## PLANNING REPORT

# Planning and Zoning Commission

## AMLIN CROSSING 24-002INF

### Case Summary

Site Location Map

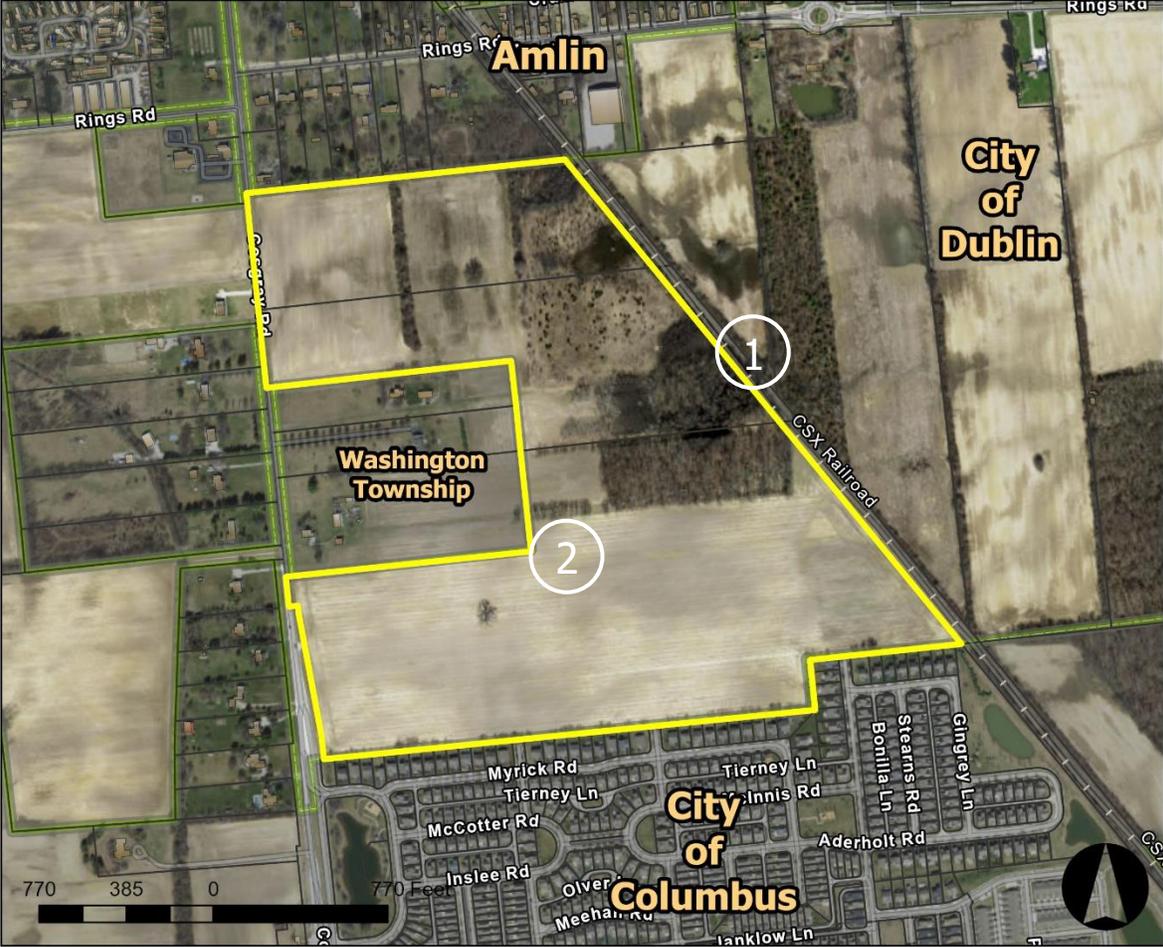
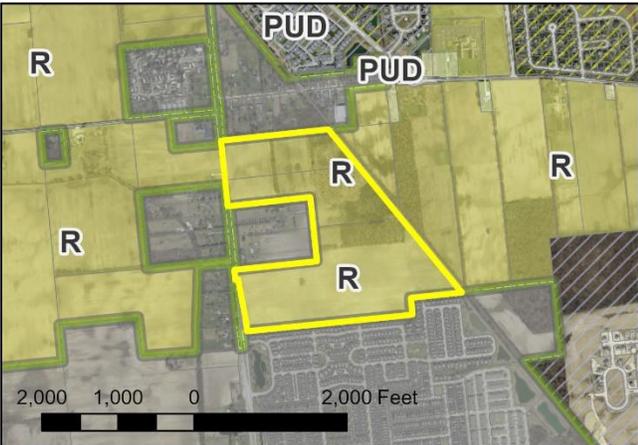
- 1 CSX RR
- 2 Tuttle Crossing Boulevard location
